NATHANIEL J. HOLT, PE

July 20, 2020

RE: Application for Site Development Plan Approval
Frank Tedesco
1462 Old Orchard Street
Tax Map: 123.01-1-15

FINAL CONSTRUCTION
PLANS
1460 OLD ORCHARD STREET
TOWN OF NORTH CASTLE, NEW YORK

2 of 8

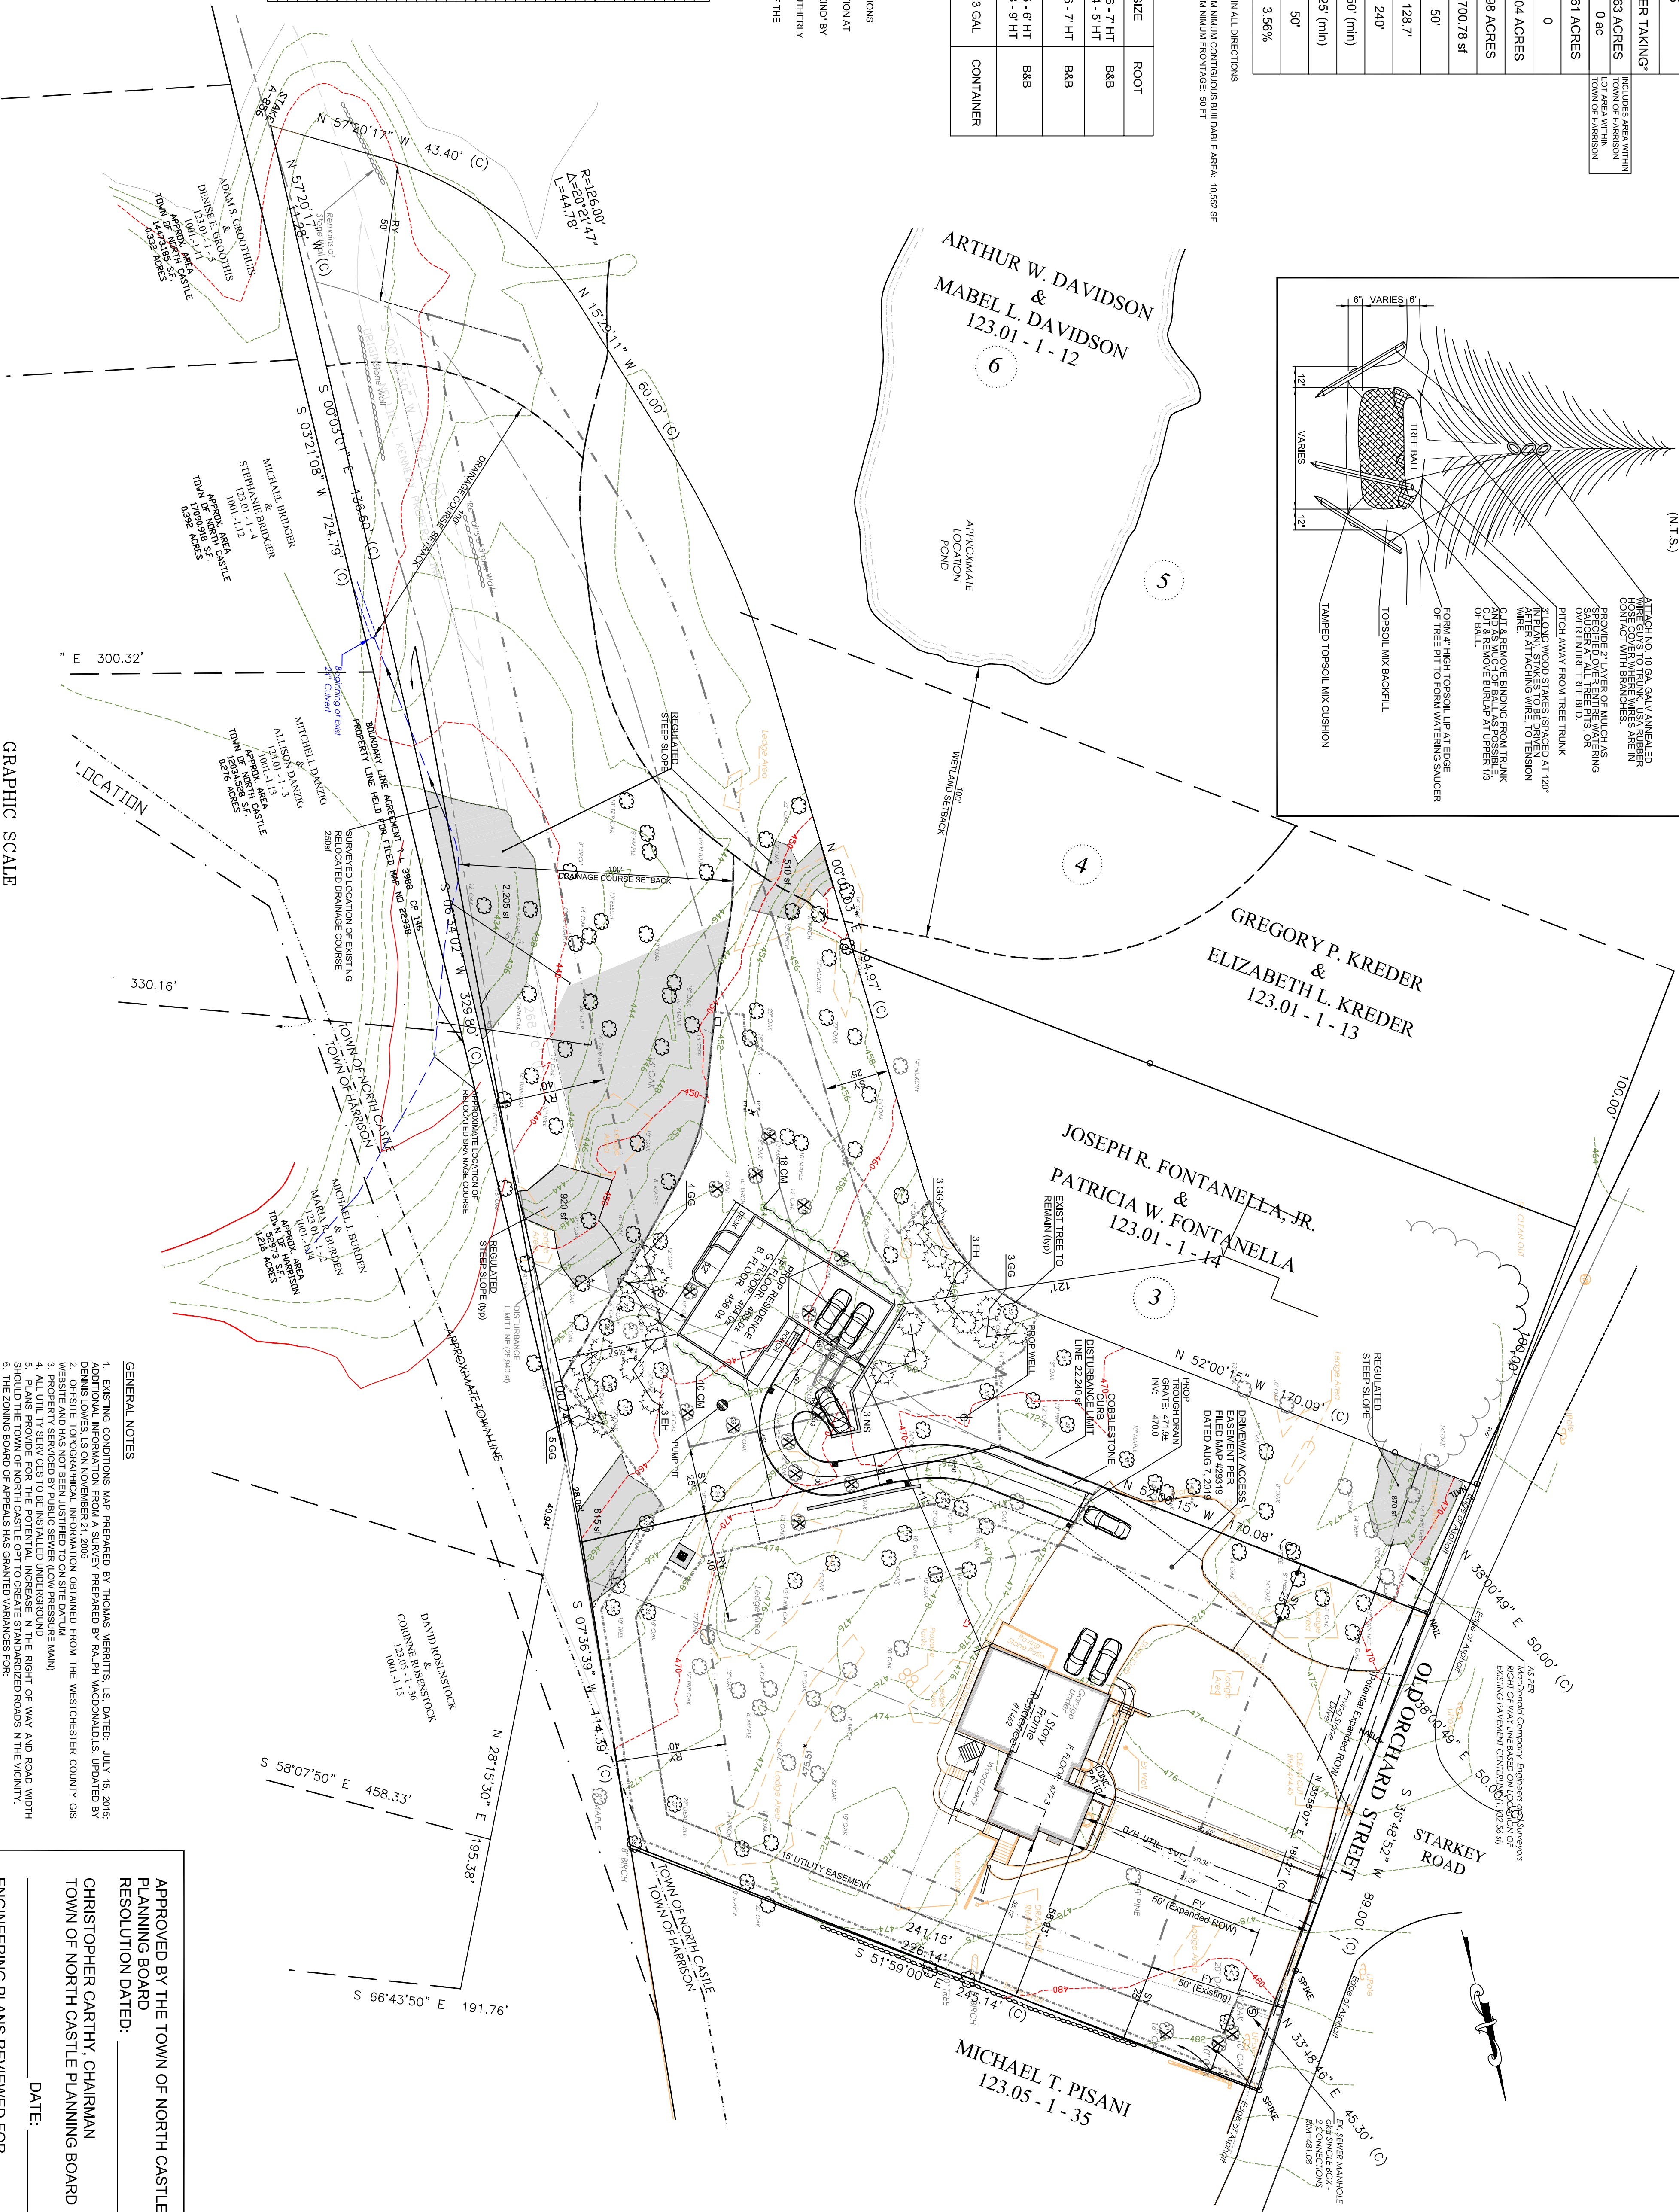
The previously proposed White Pines have been removed from the plant list and replaced with additional Arborvitae.

As you can see on the attached plans, additional space was "created" by making two revisions to the Site Plans:

1. The proposed deck on the northerly side of the home has been relocated to the southerly side. In addition to the obvious benefit, by moving the deck, the exposed foundation/access to the basement would be less visible
2. The proposed stormwater mitigation system - which consisted of two separate but interconnected infiltration systems - would be combined into a single unit. They are now located at the southeasterly corner of the house.

These two changes nearly double the available area for additional trees. While the final number of trees should still be at the discretion of Mr. Cermele, there are now 12 evergreen trees in this area. It is important to note that these trees are supplemented by seven additional mature trees. With these changes there are now a total of 24 proposed trees while only 18 will be removed due to construction.
